***Coordinated Development District Concept Plan #2015-0001
Development Special Use Permit #2014-0033
Transportation Management Plan SUP #2015-0030
Coordinated Sign Special Use Permit #2015-0031
3809-3839 Mount Vernon Avenue (Parcel Address: 3809,
3809-A, 3811, & 3811-A Mount Vernon Avenue) and 3907
Bruce Street – Mount Vernon Village Center***

Application	General Data	
Project Name: Mt Vernon Village Center	PC Hearing:	May 5, 2015
	CC Hearing:	May 16, 2015
	If approved, DSUP Expiration:	May 16, 2018
	Plan Acreage:	4.88
Location: 3809-3839 Mt Vernon; 3907 Bruce Street	Zone:	CDD#6
	Proposed Use:	Residential rental units with ground floor retail
	Dwelling Units:	478
	Gross Floor Area:	636,601 sq. ft.
Applicant: Arlandria Center LLC, represented by Duncan Blair	Small Area Plan:	Arlandria Neighborhood Plan and Potomac West SAP
	Historic District:	Not Applicable
	Green Building:	LEED Certification for Residential and LEED Silver for Retail

Staff recommends **approval** of a request to grant a 36-month extension of all previous development approvals associated for the Mt. Vernon Village Center site, subject to compliance with the staff recommendations. The project was originally approv

Attachment 1: Site Plan *(original footprint outlined in red)*

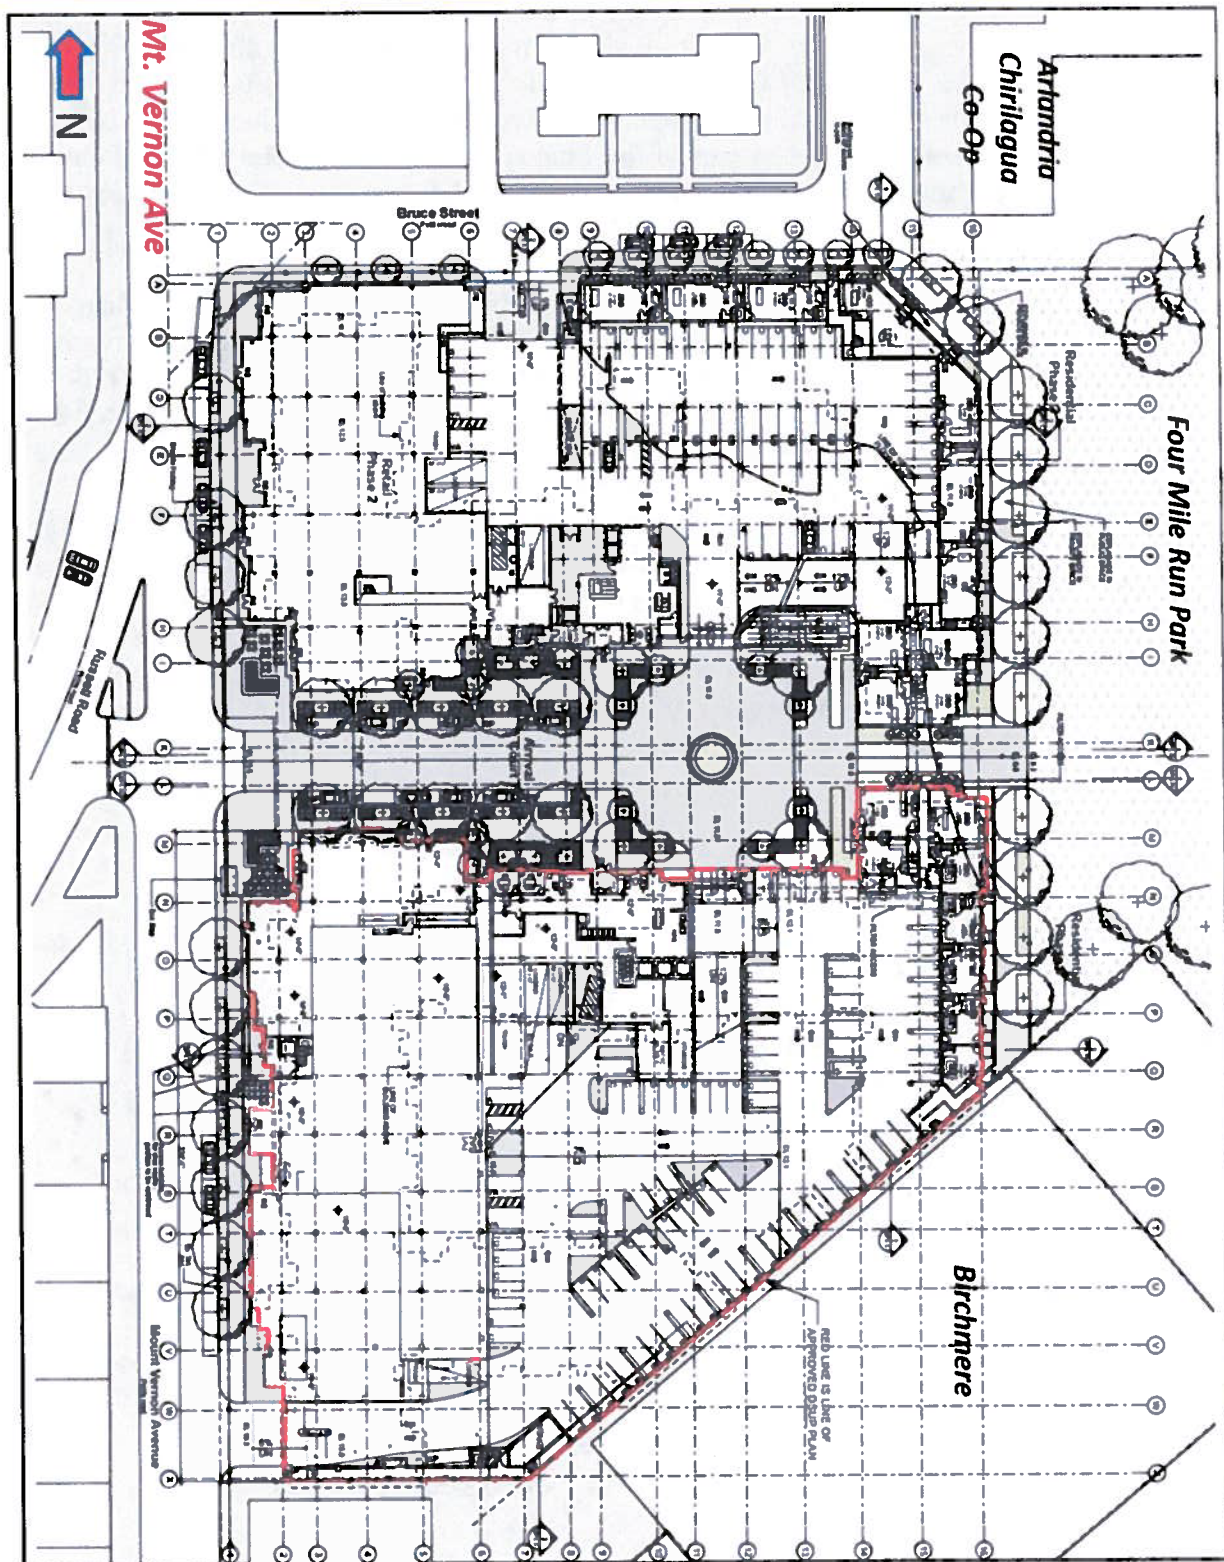
The reduction request proposed to remove the top floor on the south building, reducing the height for that building from six stories to five stories, or from approximately 70’ to 60’ high. The building was reconfigured with slightly smaller units, in order to retain the same overall number of units, and the architecture, including window placement and design details, was modified accordingly.

Due to the configuration of the uppermost floors and the careful redesign by the project’s architects, staff found the height reduction would not substantially change the appearance of the building. All other aspects of the project were proposed to remain the same, including overall building design and materials, retail square footage, unit totals and financial and affordable housing contributions. After staff review and consultation with the Arlandria Advisory Group Executive Committee, it was determined that, in this instance, an administrative approval could be made for the height reduction. Details of the height reduction were reviewed as part of the Final Site Plan.

Attachment 4: Exhibit 1, Condition 3k: Street Trees

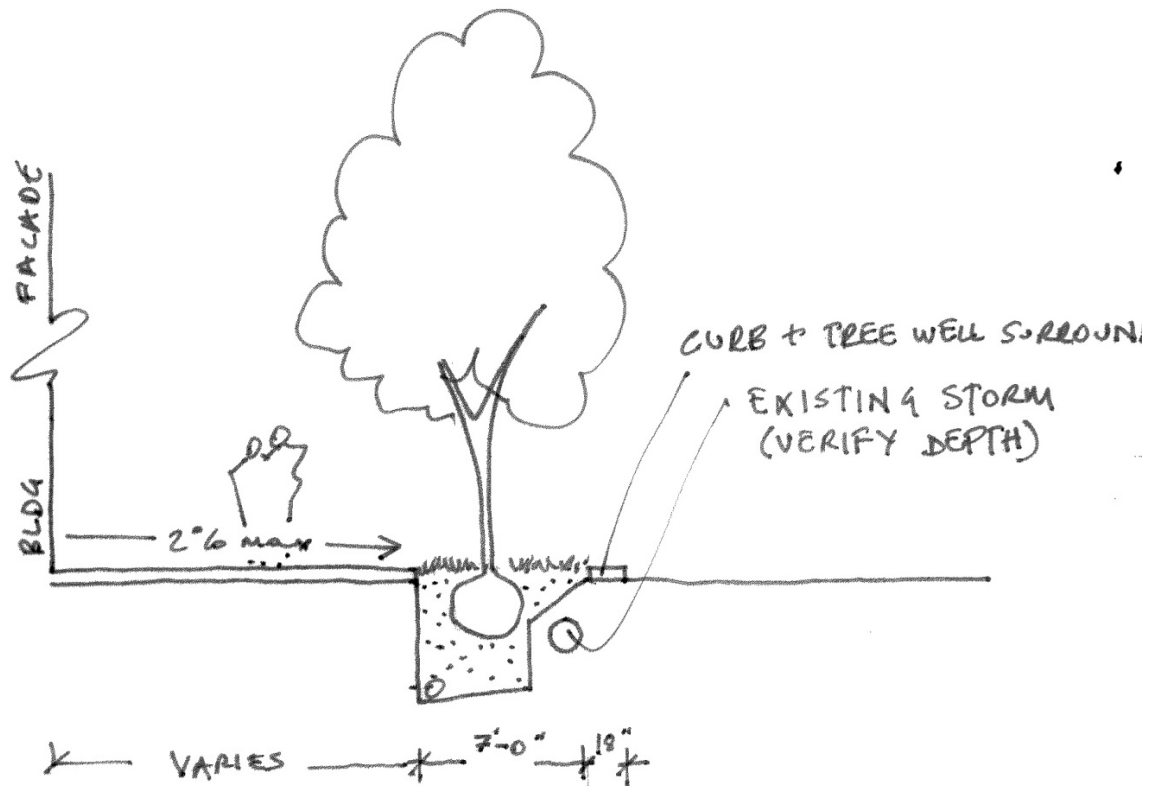
- j. No garden walls shall be constructed within the park property line. (P&Z)(RP&CA)
 - k. Provide street trees along the full frontage of Mount Vernon Ave. Locations to be determined at final site plan. In the area with potential conflict with the underground storm pipe, provide verification of the pipe depth and tree wells generally consistent with *Exhibit 1 (Attachment 4)* to the satisfaction of the directors of RPC&A and P&Z. Relocation of the existing stormwater pipe will not be required. (P&Z)(RP&CA)*
